SANFORD CONSORTIUM FOR REGENERATIVE MEDICINE

SHEET NAME
PARTIAL MECHANICAL PIPING
FIRST FLOOR PLAN - ZONE 2

MP2212

PARTIAL MECHANICAL PIPING FIRST FLOOR PLAN - ZONE 2

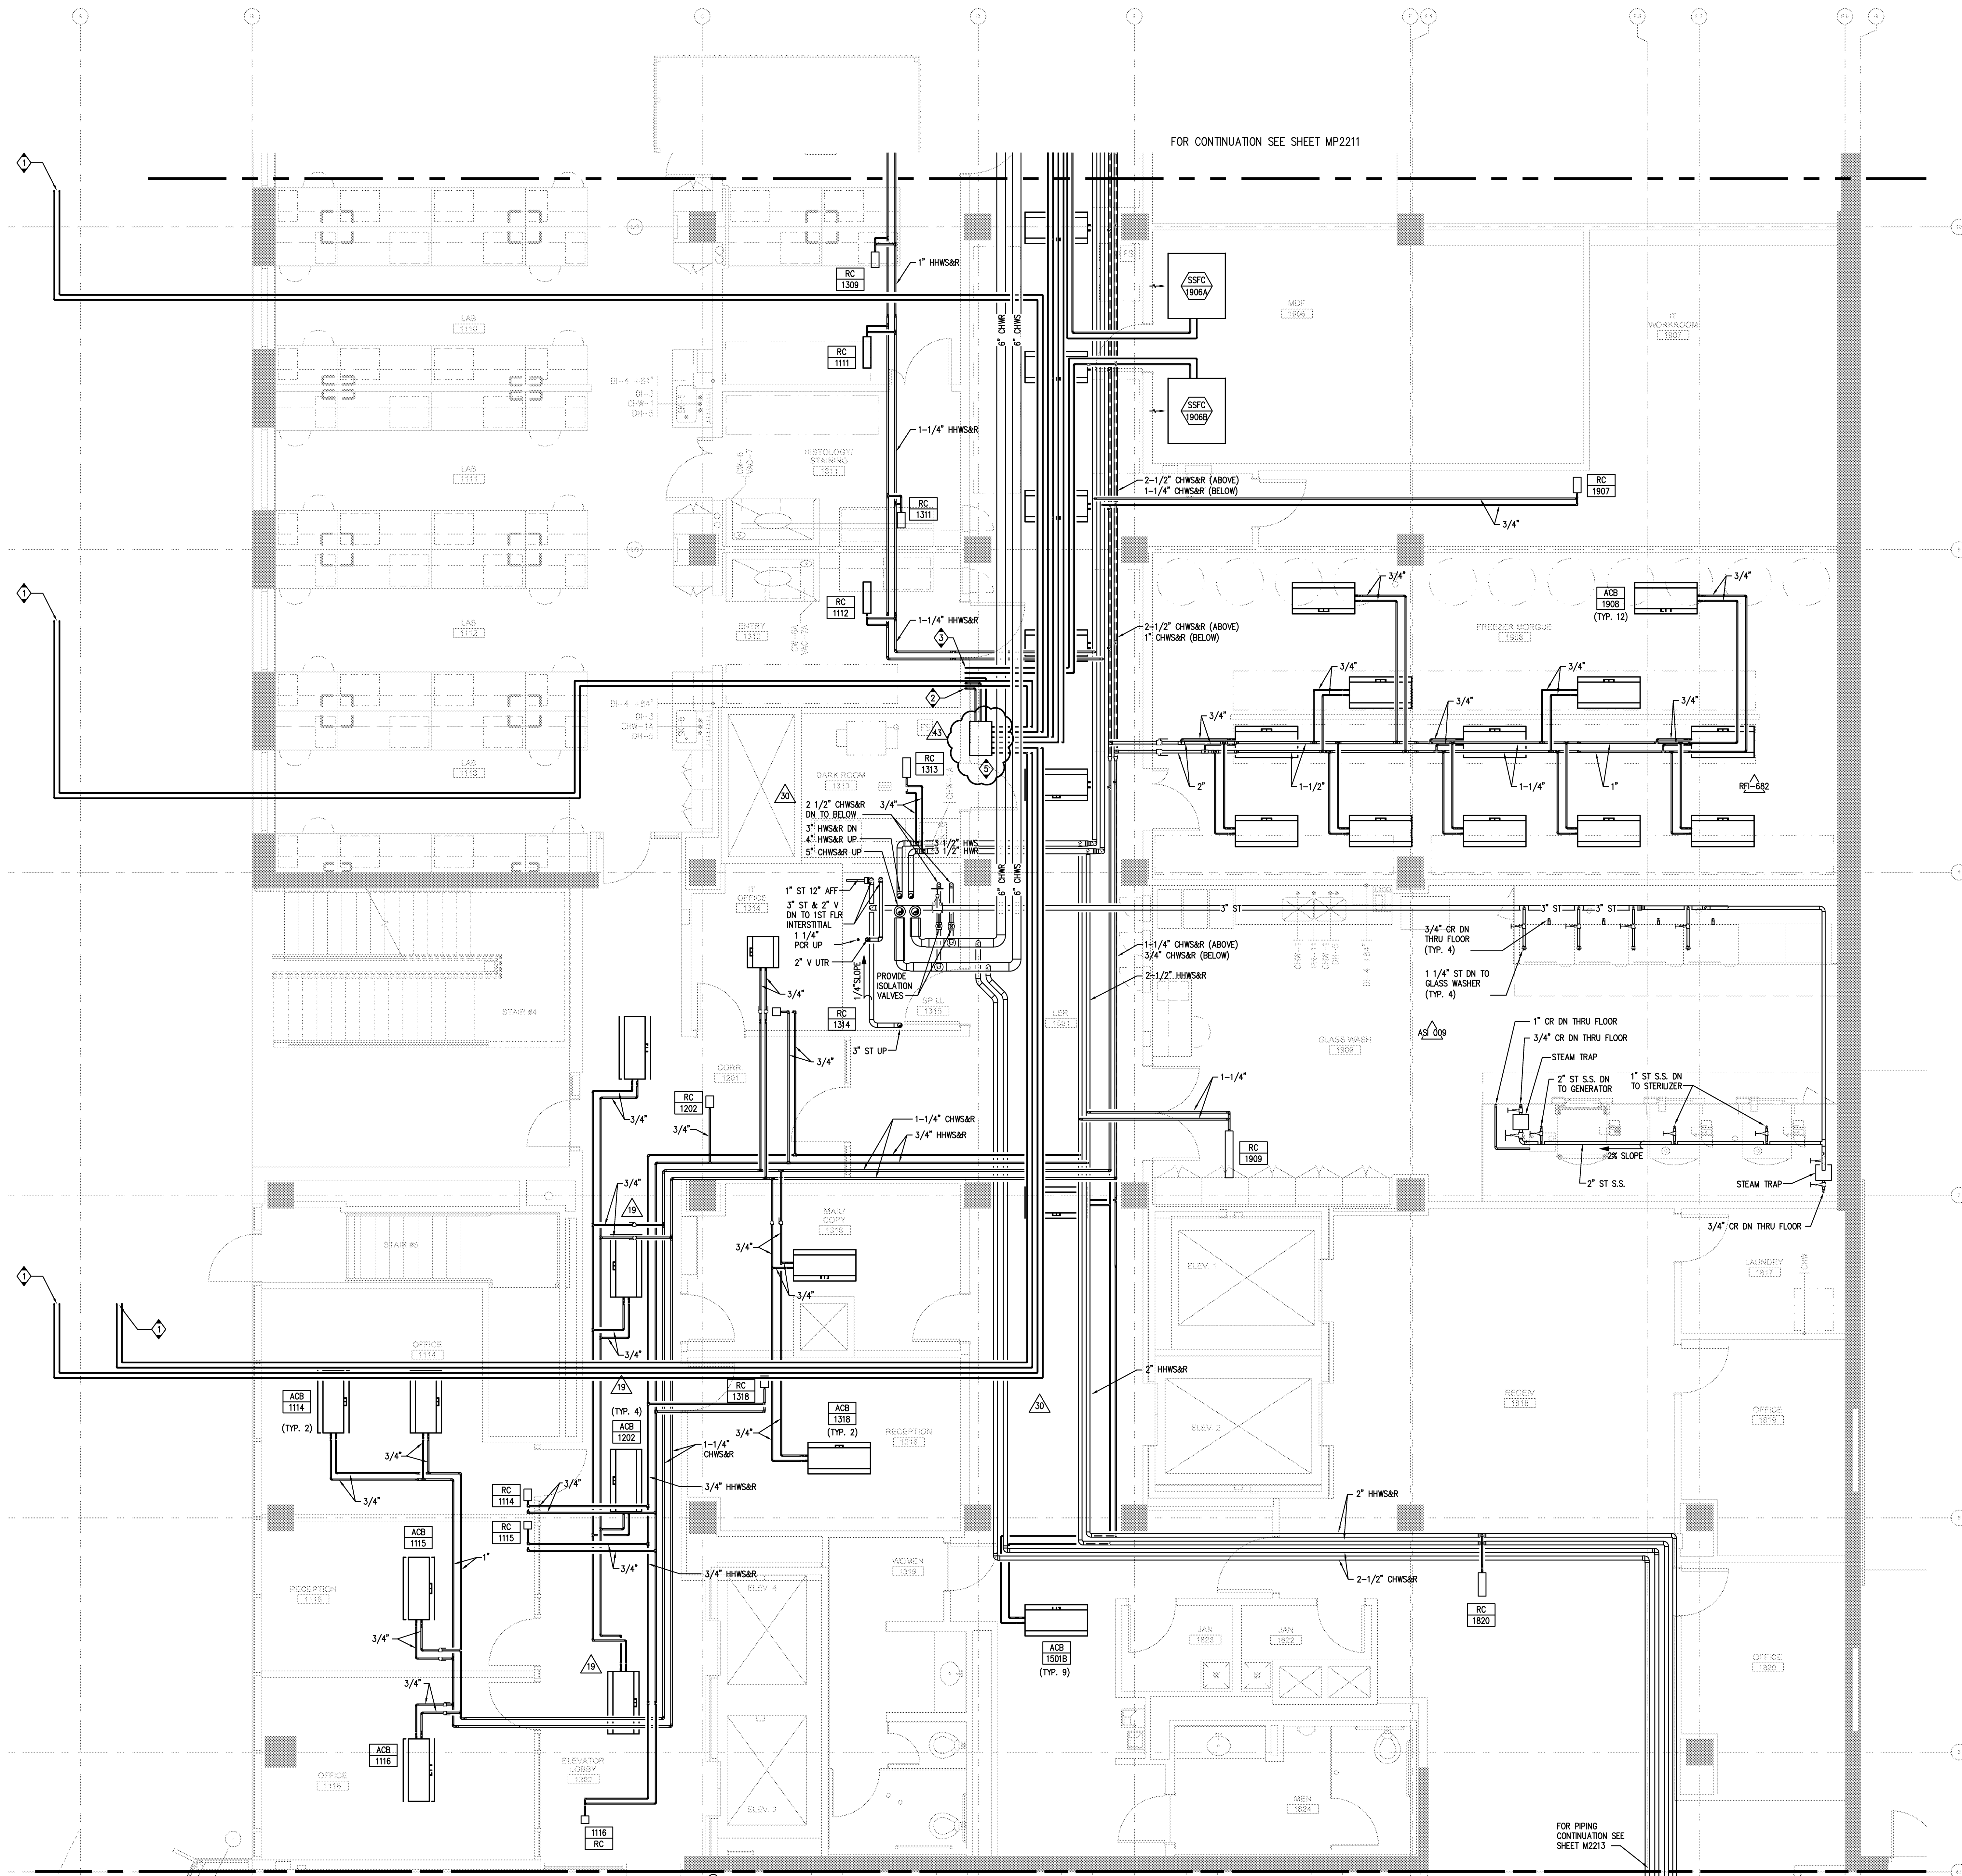
- REVISIONS:
- 1 1/2" RG & 1/4" RL UP TO 2ND FLOOR.
 - 2 3/4" & 5/8" RG OR RL PIPE UP TO 3RD FLOOR. ABANDON 3/8" LINE.
 - 3 3/4" RG & 3/8" RL UP TO 2ND FLOOR.
 - 4 12" DOWN TO 6" FUME HOOD. BALANCE TO 785 CFM.
 - 5 REPLACE SUB BC PANEL WITH BC PANEL AND RECONNECT REFRIG. LINES.
